## **Rocky Mountain Arsenal**

**FINAL PHASE I**  
**CONTAMINATION ASSESSMENT REPORT**  
**SITE 36-7: SOLID WASTE BURIAL/SANITARY PITS**  
**(Version 3.1)**

February 1988  
Contract Number DAAK11-84-D0016  
Task Number 1 (Section 36)

36-7-C -- COMMENTS AND RESPONSES

Figure 36-7-2  
FIELD BORING PROFILE FOR  
BORING 3120

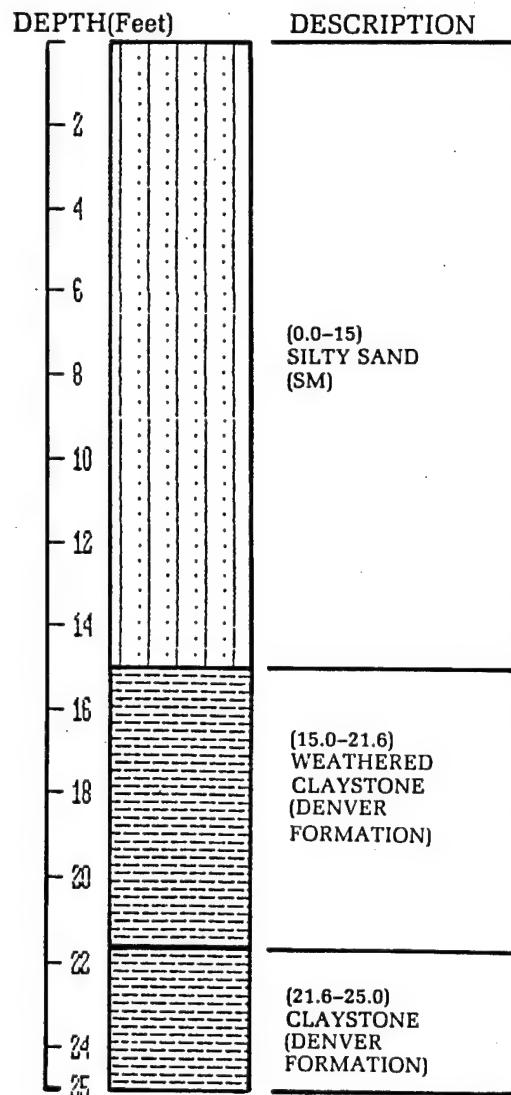
- Comment\_1:  
p. 36-7-2      This figure did not reproduce well. It is very difficult to read boring designations.
- Comment\_2:  
p. 36-7-3      Please provide the geologic cross-section described as a figure in this report.

**Figure 36-7-4  
REGIONAL GROUND WATER FLOW  
SITE 36-7  
ROCKY MOUNTAIN ARSENAL  
SOURCE: ESE, 1987**

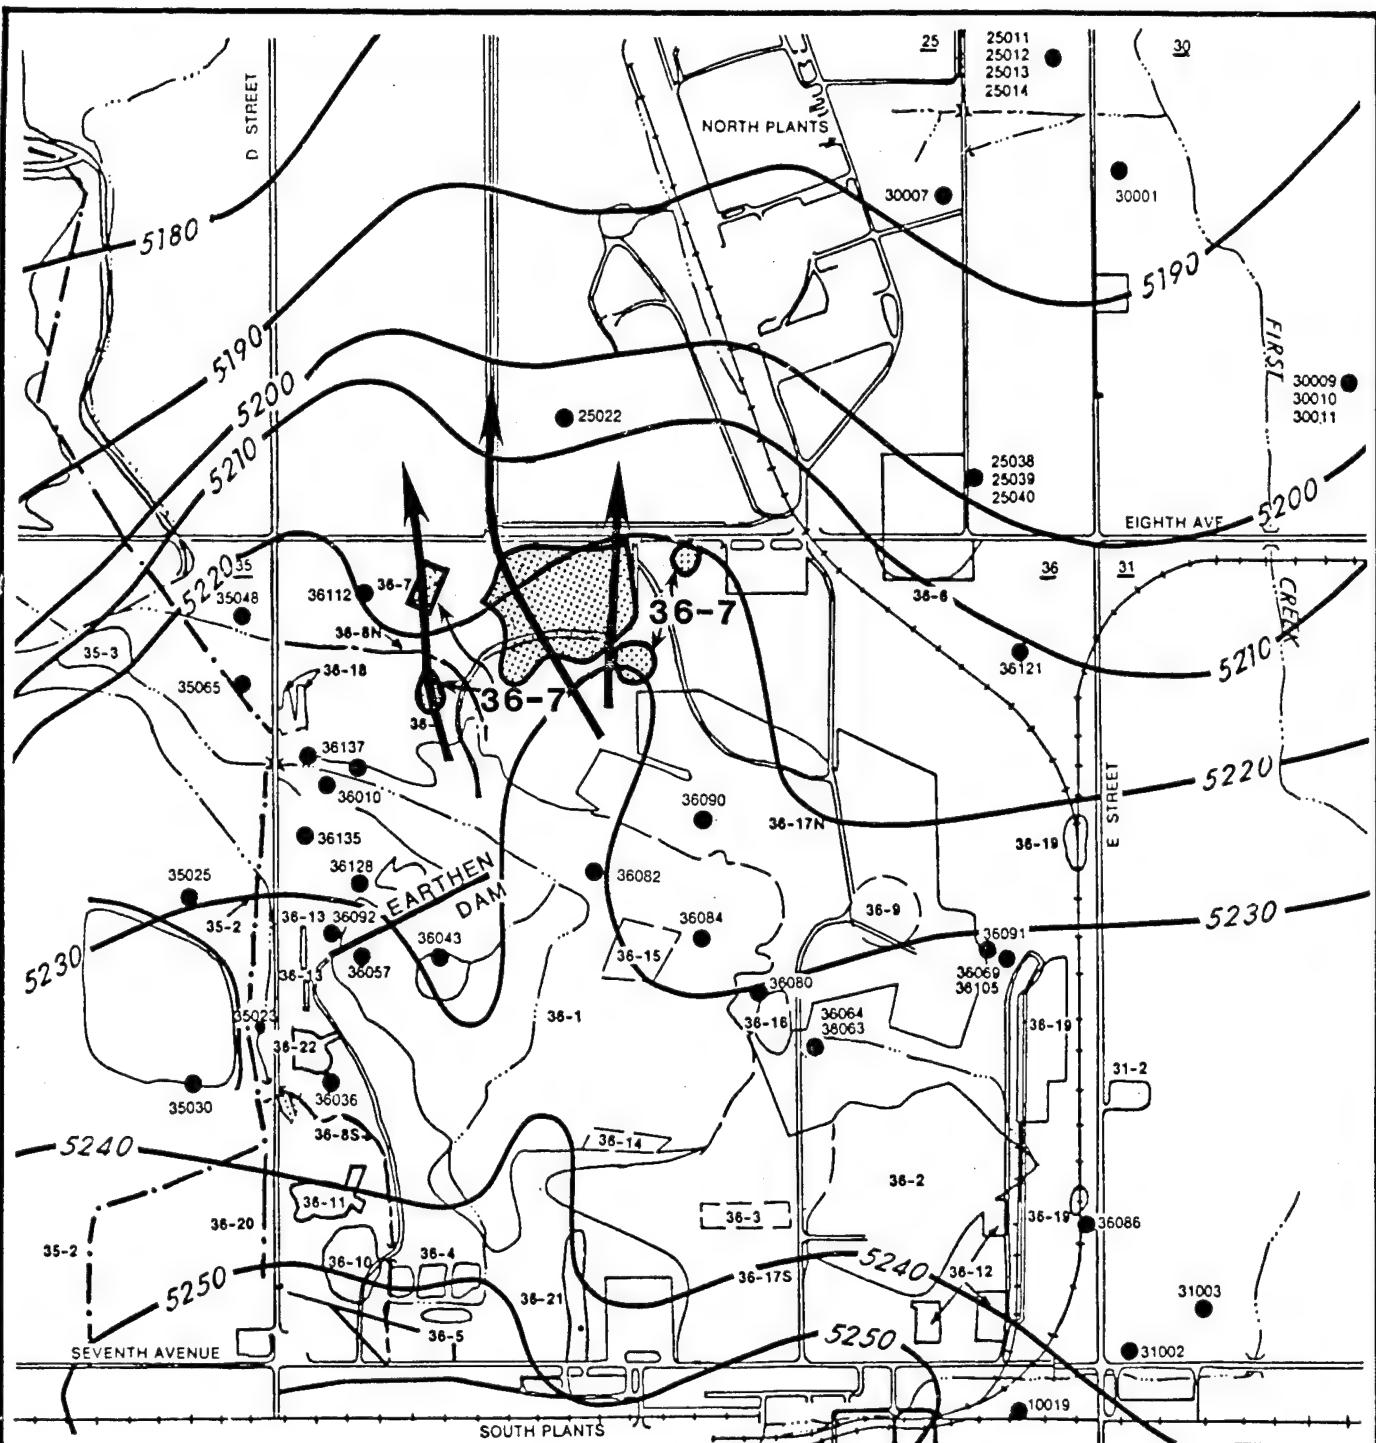
**Comment\_4:** p. 3, 1.3 Hydrology, second paragraph Wells 36116 and 36117, measured in March 1986, show water table elevations of 5245 and 5339, respectively.

**Comment\_6:**  
p. 6, Figure  
36-7-4

The measurements from these Denver Formation wells may not reflect water table conditions and were not used to generate Figure 36-7-4. Potentiometric maps for the Denver Formation are presented in the Task 4 Initial Screening Report (ESE, 1986, RIC#86238R04). Ground water levels will be further evaluated in the forthcoming Regional Study Area reports.

**Response:**

**Figure 36-7-6  
PHASE I INVESTIGATION GEOPHYSICAL RESULTS SUMMARY  
SITE 36-7**

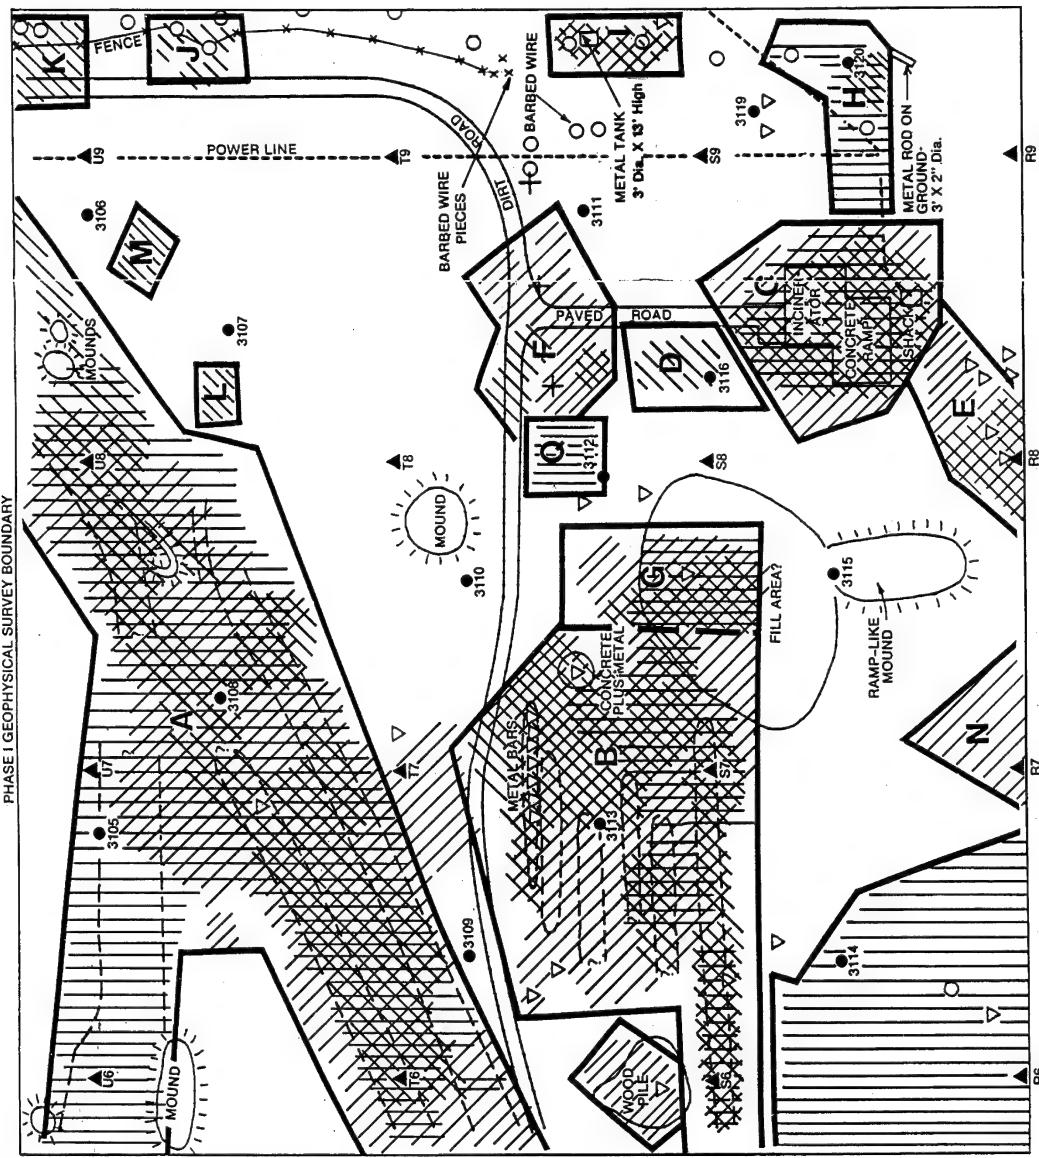
- Response:**
- The sentence has been corrected as suggested.
- Comment\_12:**  
p. 14, 3.2.3  
Geophysical  
Exploration
- Some of the anomalies appear to extend beyond the Phase I Geophysical Survey Boundary (this is noted in the text for Anomaly A). The survey should be extended in a subsequent study to define the limits of all anomalies. Does the geophysical survey boundary cover the site boundary? Site boundary should be shown on Figure 36-7-6.

- Comment\_13:**  
p. 17, last  
paragraph
- The association of Anomaly D with the Shell Chemical incinerator should be explained, i.e., how was Anomaly D "produced" by the incinerator?

- Response:**
- Some geophysical anomalies may extend beyond the grid boundaries; e.g., Anomaly A, which is partially derived from the presence of a buried pipeline running through the area. As such, extension of the study area would not further serve the survey's purpose, which was to assist in identifying trenches within the site to enable Phase II borings to be placed more effectively. The geophysical grid does cover the main area of the site, as can be seen by comparing the boring locations shown on both figures as a means of correlating locations without unnecessarily confusing the presentation.

**Response:** The geophysical methods used measure variations in electromagnetic fields. Therefore, they are sensitive to the presence of metallic objects both under and above ground. As explained in the geophysical investigation report, the proximity of fence lines, power lines, or metal structures such as the incinerator, will produce a measurable response or "anomaly" on the instrumentation. Considerable interpretive effort is required by experienced personnel to evaluate the implications of the raw data from the various instruments. Only then can judgments be made as to which responses indicate possible trenches and which are due to potential interferences, such as the incinerator.

Figure 36-7-8  
PROPOSED PHASE II INVESTIGATION BORING LOCATION MAP  
AND CHEMICAL ANALYSIS SCHEDULE  
SITE 36-7  
SOURCE: ESE, 1987

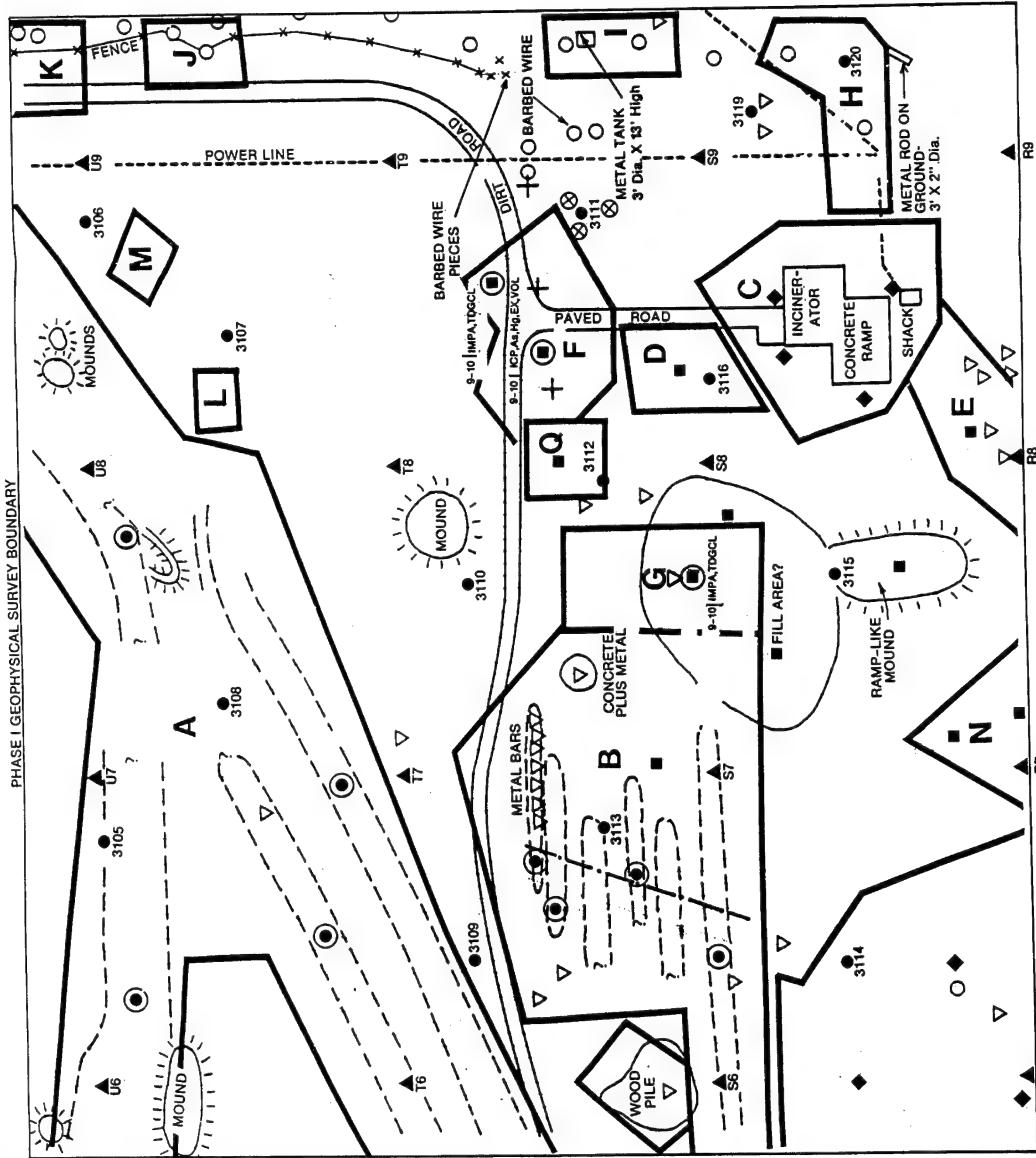
Comment\_18: Why aren't the mounds near borings 3110, 3106, and grid marker U6 being investigated?  
p. 38, Figure 36-7-8

Comment\_19: In the last sentence, it should be noted that sampling depths of borings in pits are relative to the trench bottom, per legend on Figure 36-7-8.  
p. 39, fourth paragraph

Response: Photographic and physical evidence indicates the various mounds found in this area are spoil piles from excavations (see Section 2.0). The large mound south of Boring 3115 will be sampled as a precaution. The area southwest of Boring 3114 was used in recent years for surface dumping of waste materials such as wood and cardboard, which was since removed (see Section 2.0). The borings are designed to check for residual contamination from this activity. One of the borings was incorrectly located in drafting the figure and has been adjusted.

Response: The sentence has been changed as follows: "The borings in the pits will be drilled to 5 ft and sampled at the 0-1 and 4-5 ft intervals as measured from the pit bottom."
